**NOTICE OF A REGULAR MEETING
BONDURANT PLANNING AND ZONING COMMISSION
MARCH 24, 2022**

Item No. 6.b.
For Meeting of 3/24/2022
Resolution

TITLE: - RESOLUTION NO. PZ-220324-09: Considering recommended approval of the Edgeland Bondurant Preliminary Plat and Site Plan at Outlot R of the Quail Run Phase 2 Preliminary Plat development area.

TITLE: - RESOLUTION NO. PZ-220324-10: Considering recommended approval of the 1001 23rd Street SW Site Plan

DIMENSION PLAN

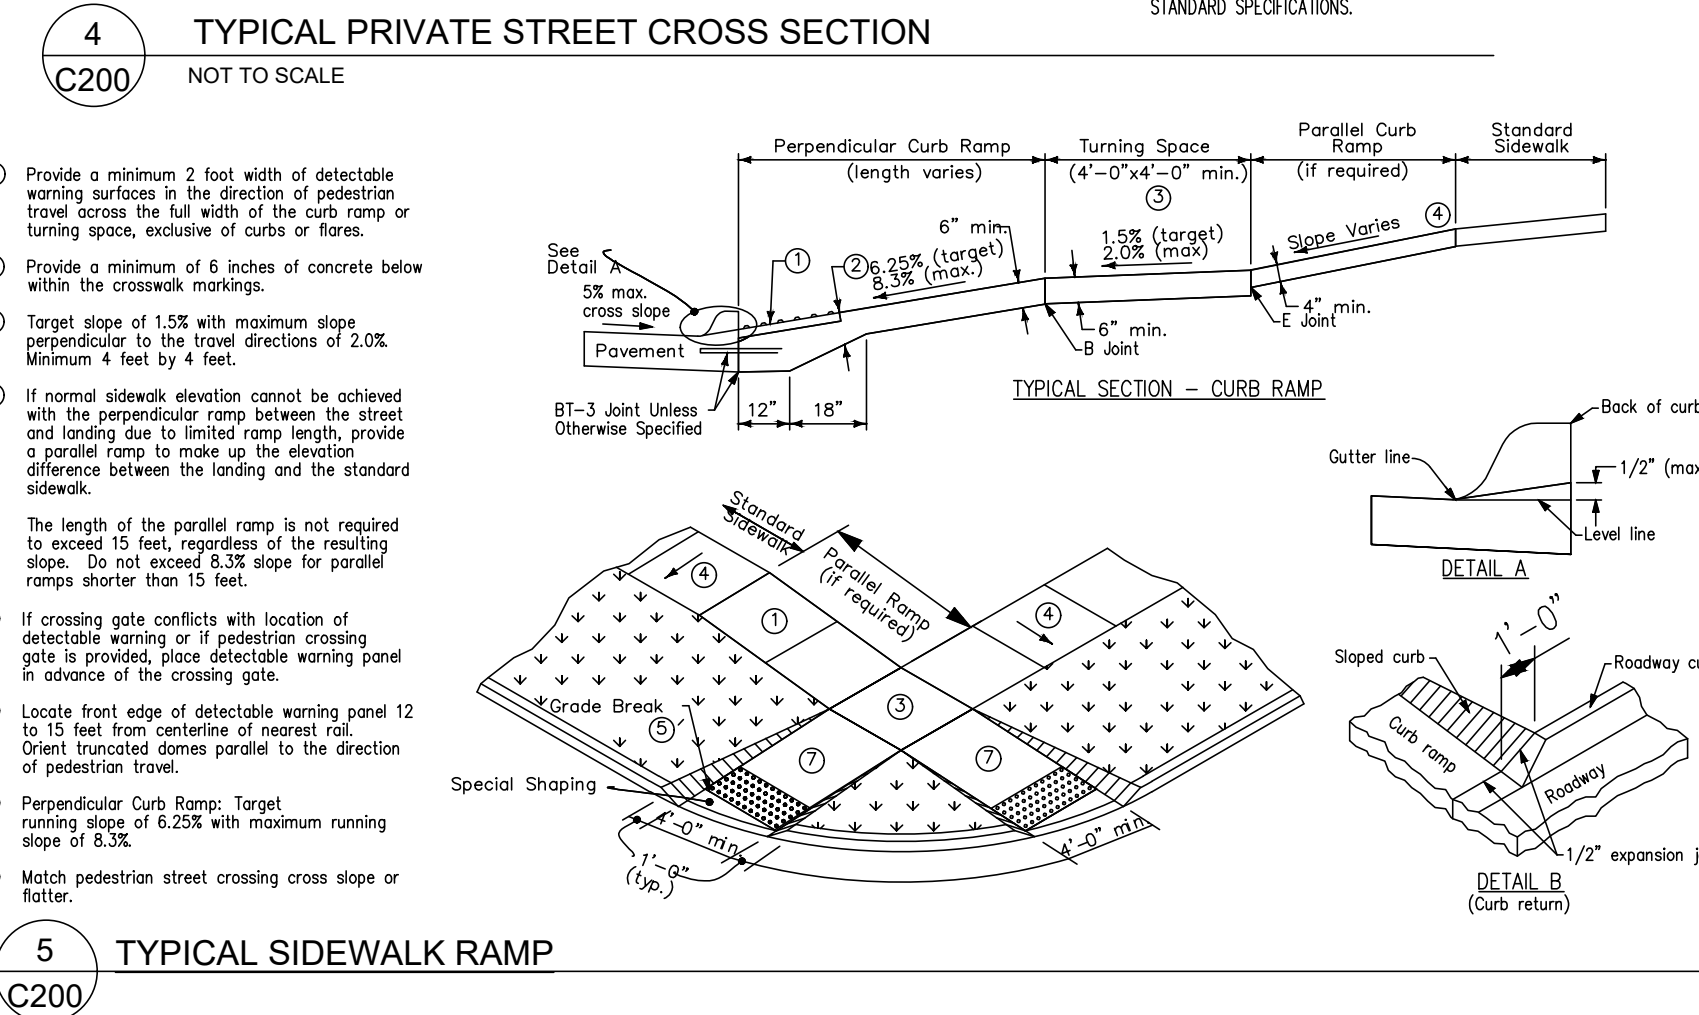
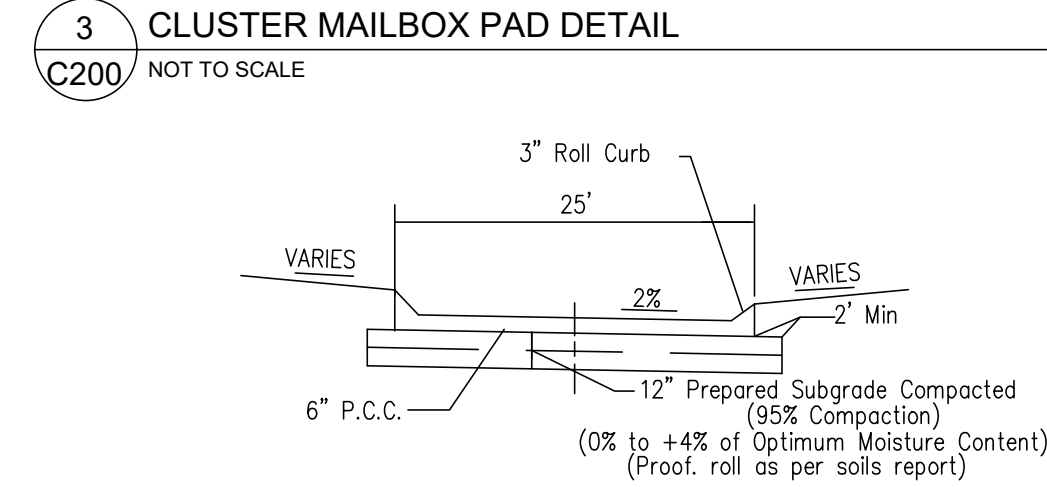
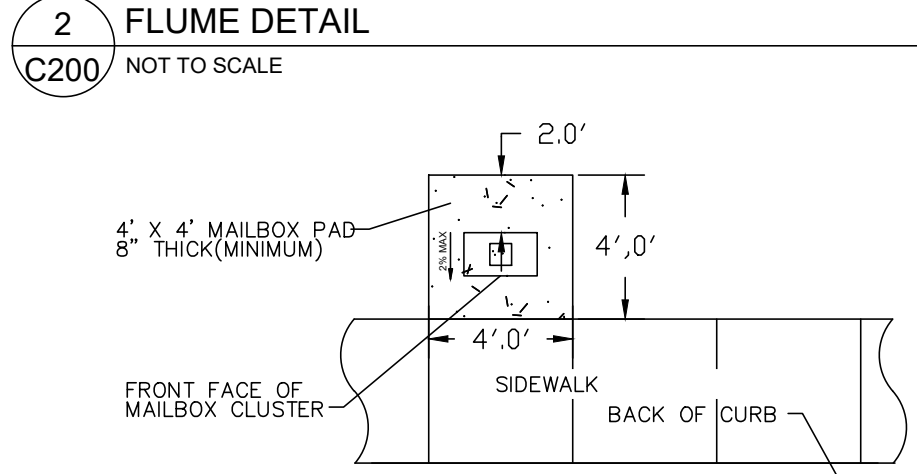
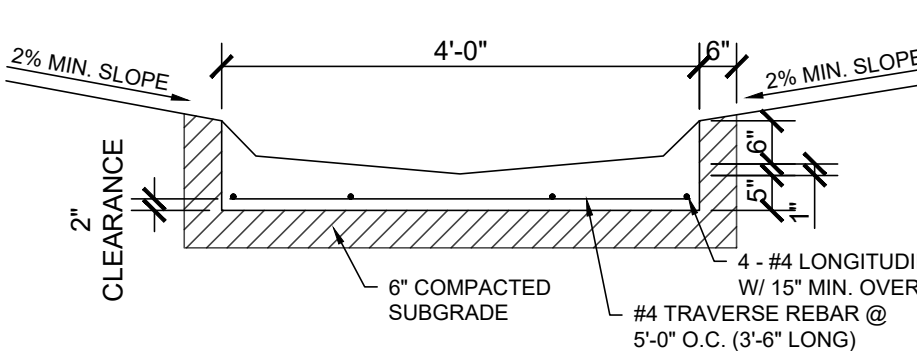
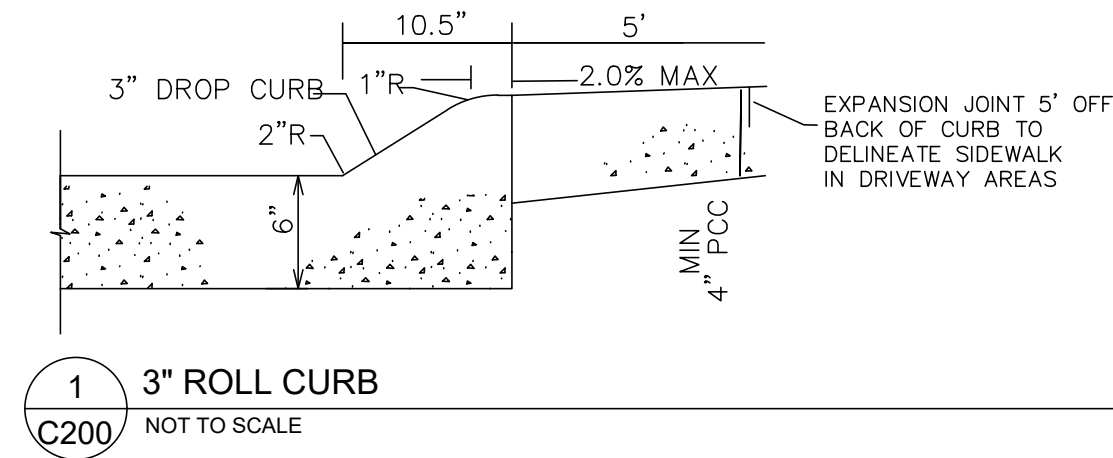
of the Quail Run Phase 2 PUD. Developer to provide clarification on if each unit will be on its own, individual lot or if all units will be constructed on one lot. If each unit will be on its own individual lot, developer to confirm that each lot will be at least 400 SF with a minimum lot width of 20'. This has been factored in as part of the attached P&Z recommendation resolution.

The development proposes 7 guest parking spaces within the development off of proposed Street B. The preliminary plat/site plan shows these guest parking stalls will be striped and will have curbing.

6. That the preliminary plat/site plan be updated to better clarify if each dwelling unit will be on its own, individual lot; if so, preliminary plat/site plan to confirm that each lot will meet the 400 SF minimum and 20'-wide minimum lot requirements per the approved Quail Run Phase 2 Preliminary Plat. Also, if dwelling units will be on their own, individual lots the common space, including the private stormwater basin area, must be labeled.

REVISED AS PER CITY COMMENTS

LANDSCAPE PLAN

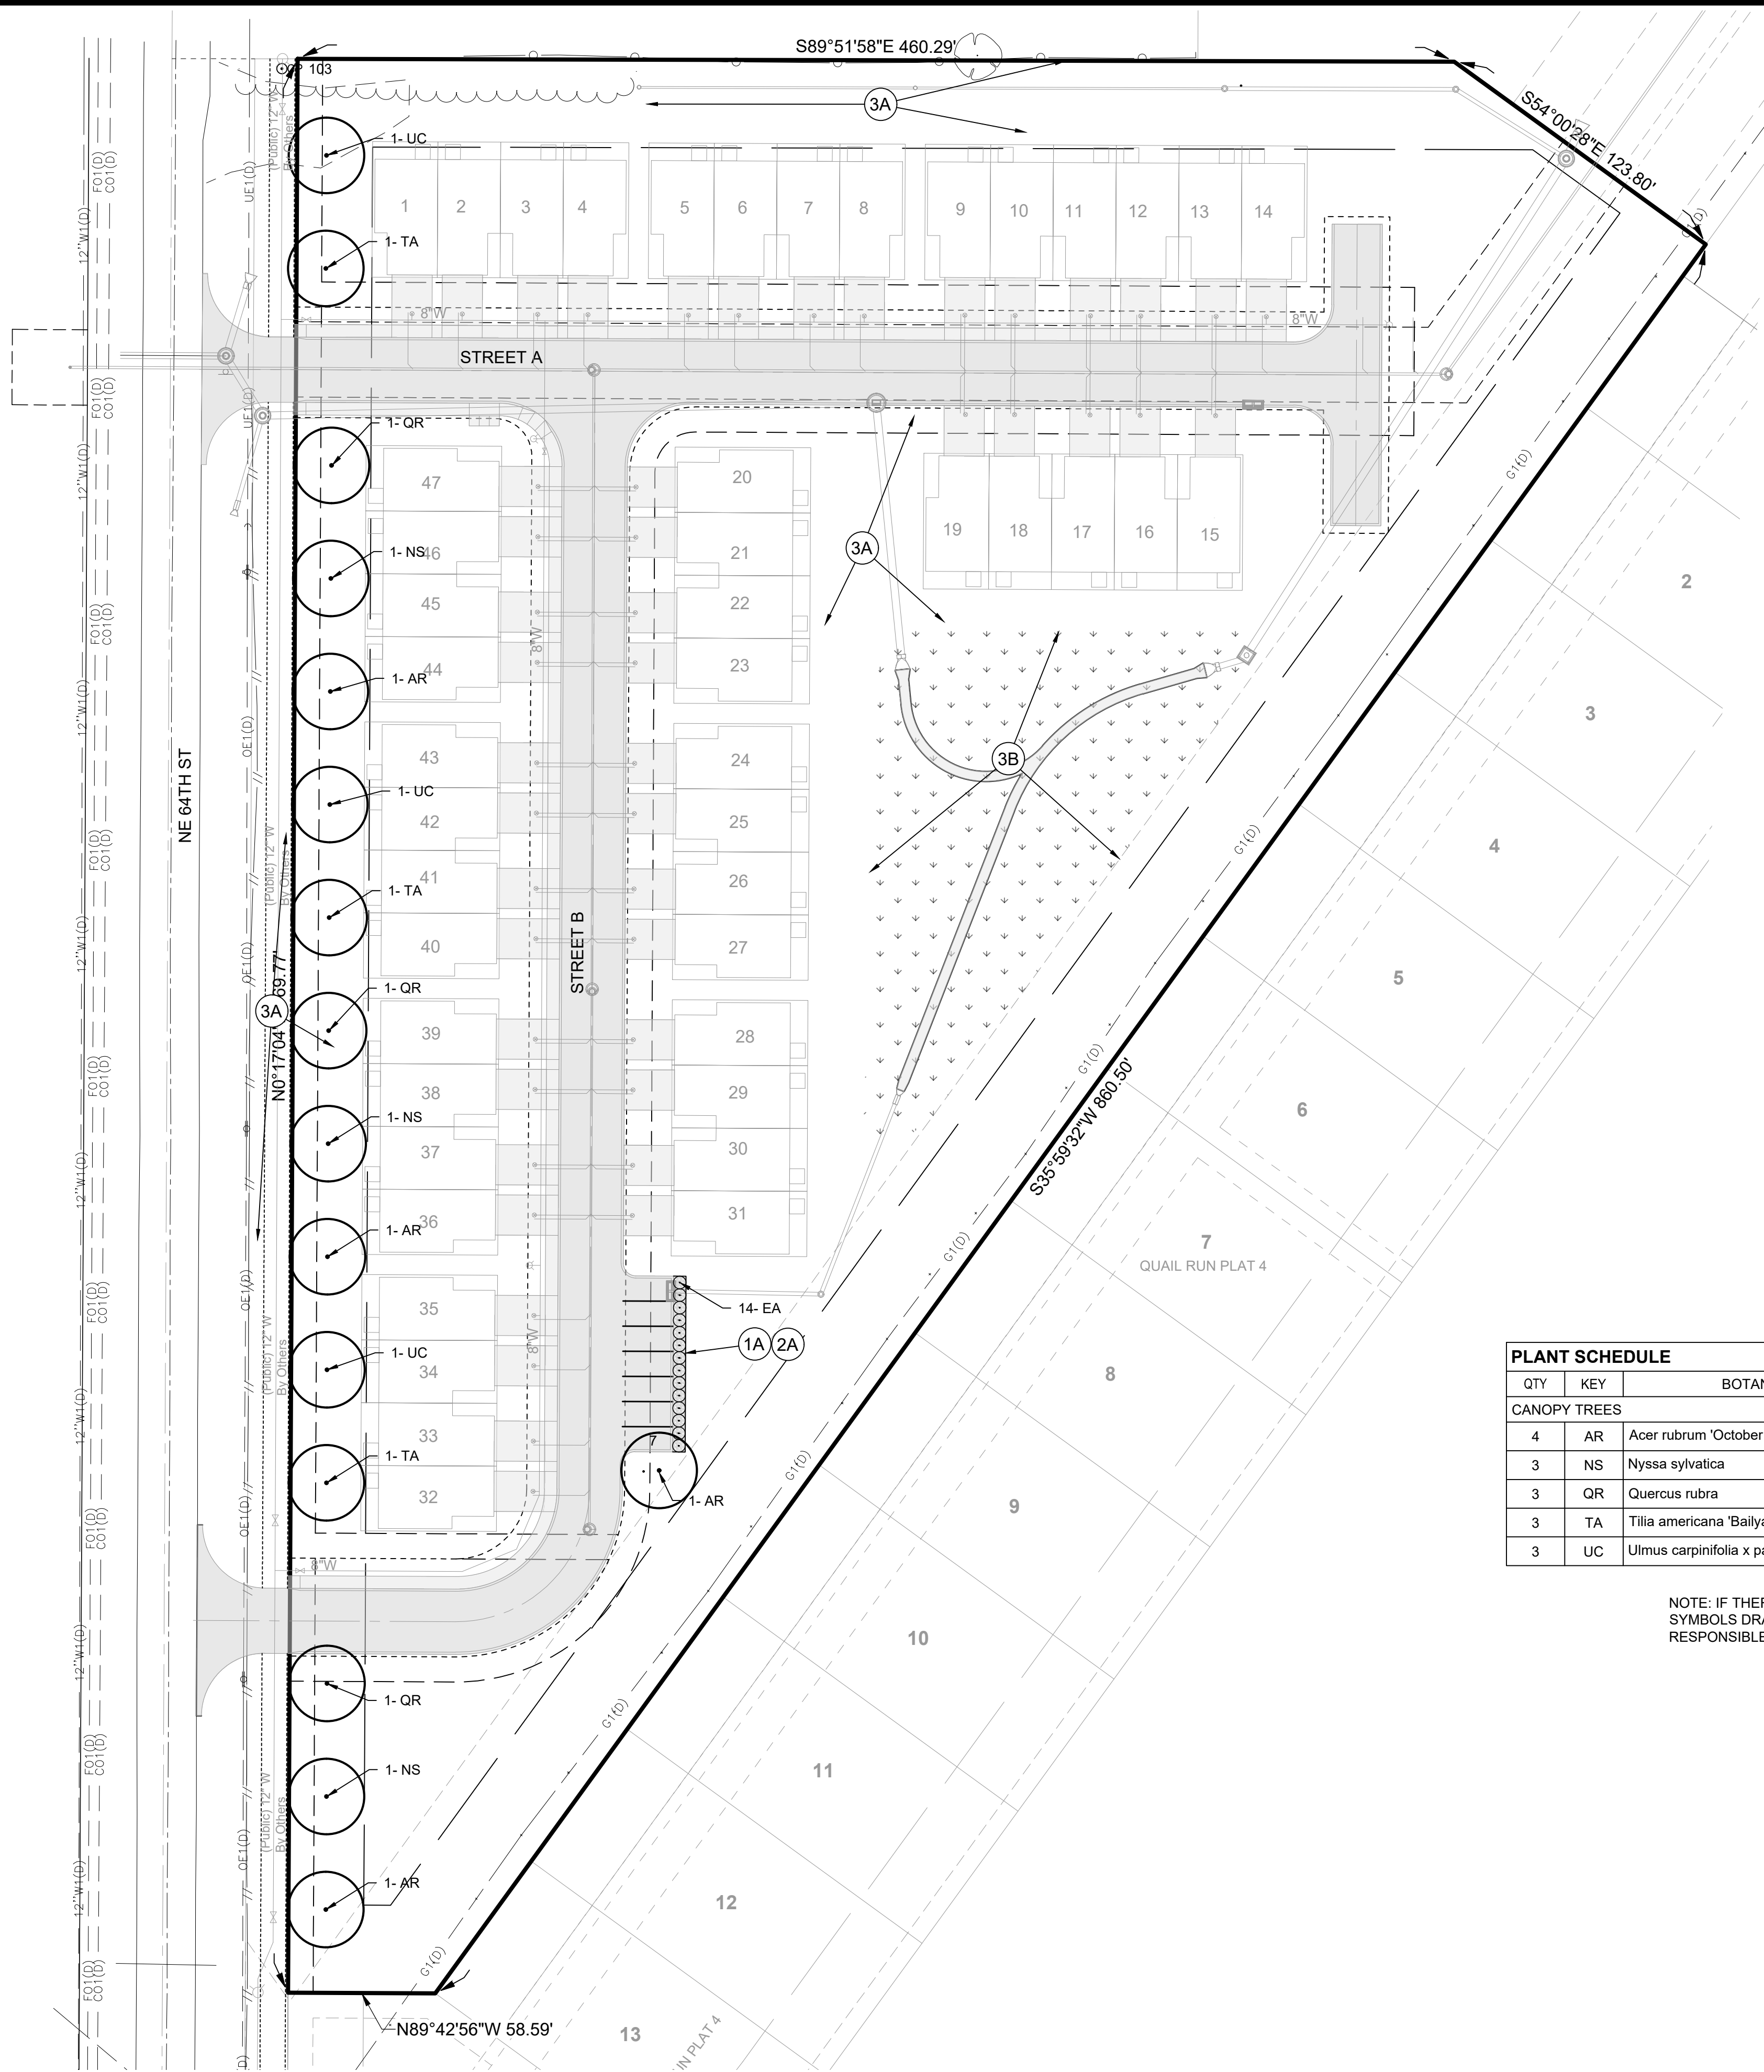
Landscaping notes - Chapter 182 of the City Code requires that at least 1 tree must be planted for every 50' of street frontage. The site has a total of 769.77 feet of frontage, requiring 16 plantings in the required front yard area. The submitted landscaping plan provides an incorrect street frontage calculation and will need to be updated to reflect the 769.77' of street frontage. Additionally, the landscaping plan will need to be updated to show that the deciduous trees planted will be a minimum of 1 3/4" caliper.

3. That payment in lieu of public parkland dedication is paid prior to final plat consideration.
4. That the landscaping plan be updated with the correct street frontage calculation and the correct minimum tree planting size requirements.

716 LF FRONTAGE / 50 = 14.32 TREES - OR - 7 STALLS / 6 = 1.2 TREES
(15 TREES PROVIDED)

EDGELAND TOWNHOMES - 4 PLEX

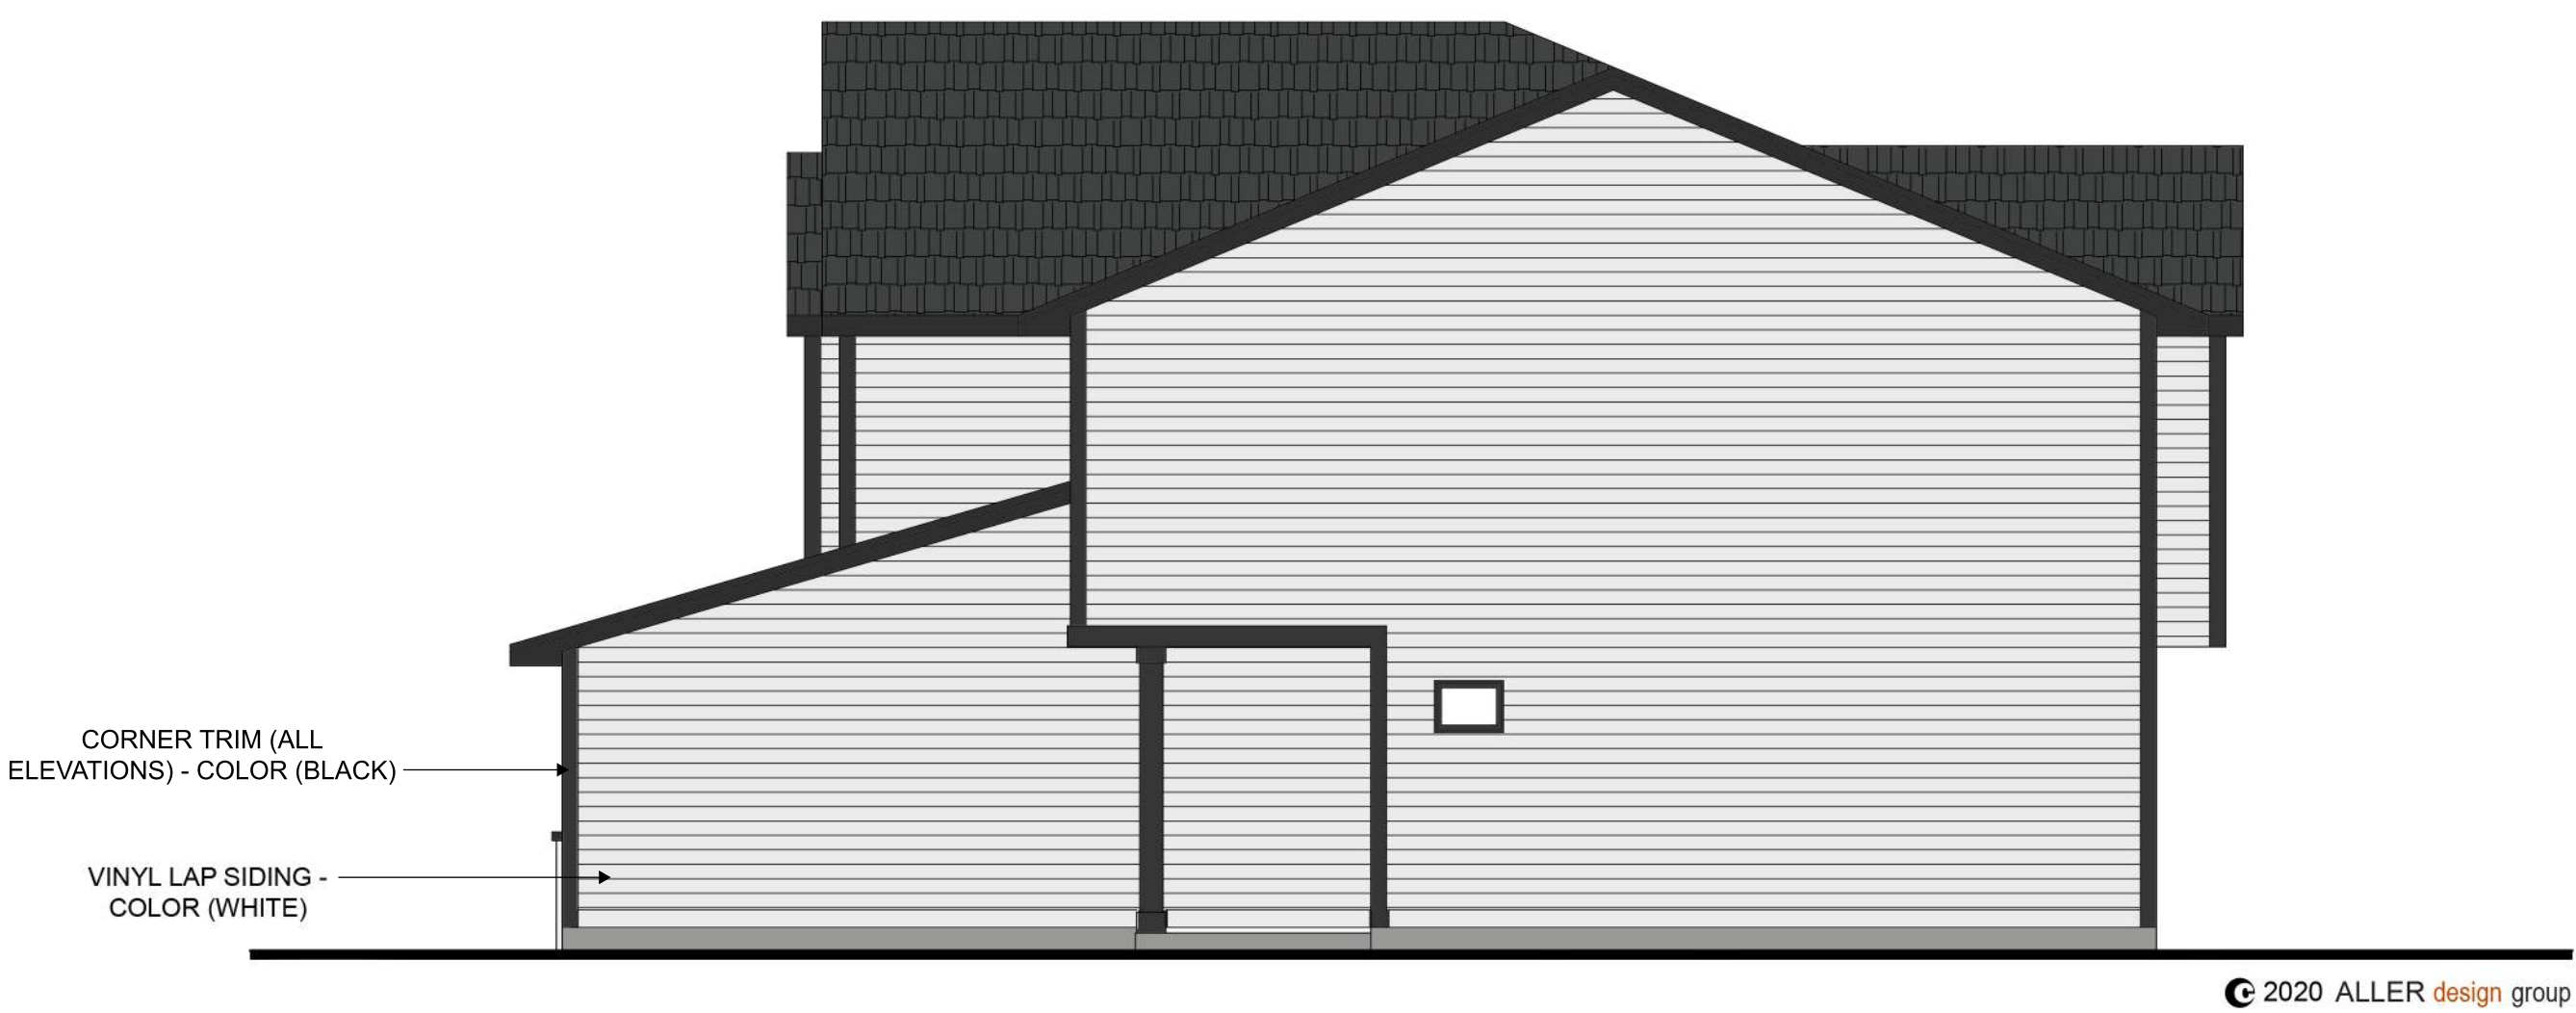
- Developer to show/confirm that each elevation facing a public right-of-way or visible from the public right-of-way is at least 20% brick, stone, or other similar material. An elevation is only not required to meet this 20% minimum when it's screened from view of the public right-of-way. Note on this 20% - door and window openings can count toward this 20% minimum if they are surrounded by

- Developer to confirm that at least every 50 linear feet, the wall and/or roof planes will contain offsets or setbacks with a differential in horizontal plan of at least 2' on all elevations. *Developer has verbally noted that this requirement will be met, but they will follow up in writing.*

7. That the building elevations are resubmitted to show compliancy with the building design/material requirements of Chapter 179 of the City Code (or a variance is sought regarding the increase in garage %).
